Applicant : David W. Clarke et al.  
Serial No. : 09/921,293  
Filed : August 3, 2001  
Page : 14 of 25

Attorney's Docket No.: 02052-100001 / 00,012

Amendments to the Drawings:

FIG. 15

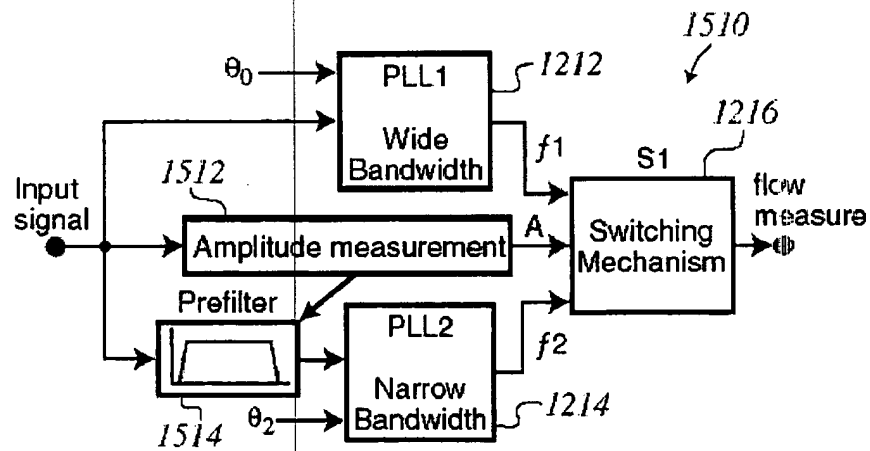
In Figure 15, (i) the arrow dangling from the lower left corner of prefilter 1514 has been removed, and (ii) an arrowhead has been added to the connection between prefilter 1514 and amplitude measurement 1512.

FIG. 29

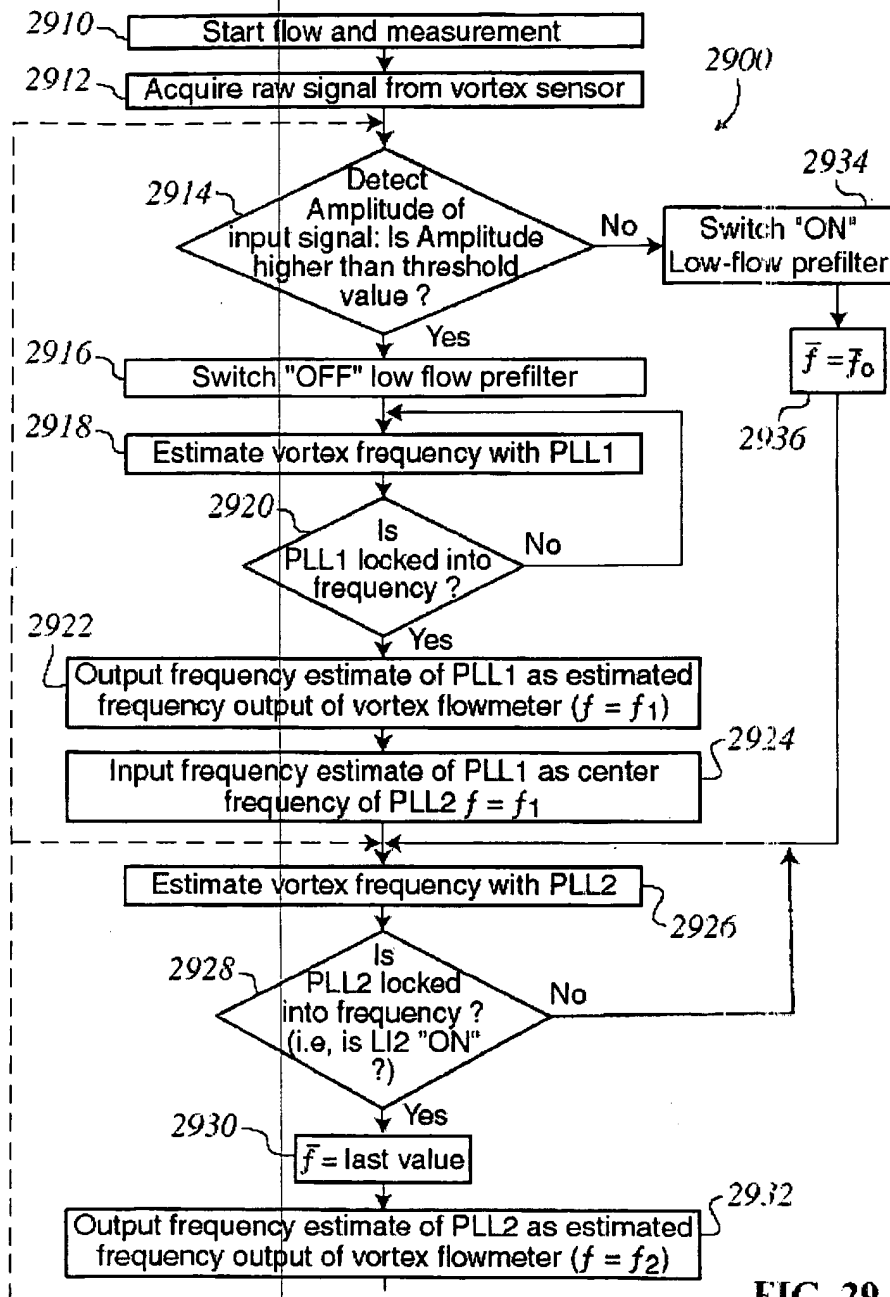
In Figure 29, "perfilter" has been changed to "prefilter" in block 2916, as shown in the originally-filed drawings.
